Staff Report to the
Municipal Planning Board
September 20, 2022

ANX2022-10008
GMP2022-10023
ZON2022-10020

10 S. IVEY LANE

Conceptual Development Plan

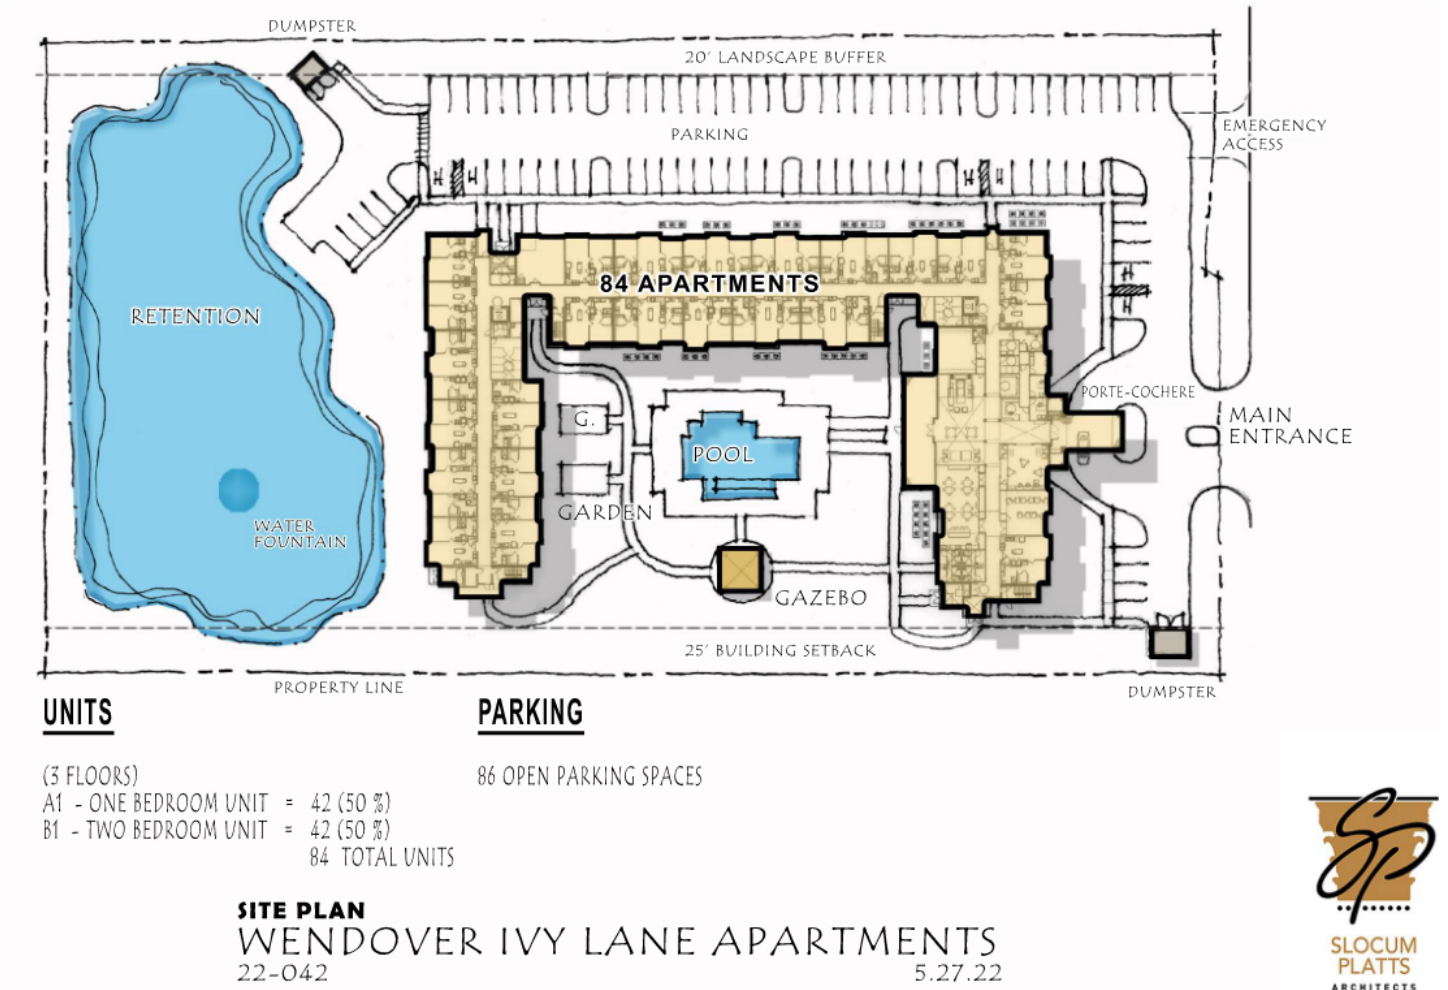
A conceptual development plan can be found on page 9 of this staff report. It includes the subject property and the property to the south to make a unified development site for a multi-family residential development. The applicant must submit a master plan application, and at the time, a more in-depth review of the site plan will be reviewed by staff.

This plan is conceptual in nature and is not approved. A Master Plan is required and will include a more detailed, code compliant, site plan.

The site review of the conceptual designs presented is preliminary and cursory in nature, as such, the comments communicated are not official determinations. The intent of comments provided is to alert designers to conditions and/or other considerations that require a deeper consideration of the FFPC, Florida Fire Code, NFPA 1. 18, State administrative requirements and City of Orlando, Municipal Code (Chapter 24) Fire Prevention, when finalizing the design for formal plan review.

1. The architectural design of the building, floor plans, life safety egress system, fire protection systems, and fire department access will be reviewed in detail for State, Fire Code, FFPC and City Fire Code compliance at the time of permit application for formal plan review of 100% drawings. ZERO LOT LINE BUILDING DESIGN. The conceptual design should indicate the location of stairs in relation to the access road, hydrants – existing and proposed, sprinkler riser room, fire pump room, and access roads – existing or proposed. The following conditions are to be considered in zero lot line designs.

2. REQUIRED ACCESS. The Orlando Fire Department requires access to two sides of a building or structure.
3. HAZARD DETERMINATION. The location of a hazard natural or manmade cannot be predetermined. As such designs incorporating predetermined locations for staging by OFD apparatus are not applicable for review of fire department access.
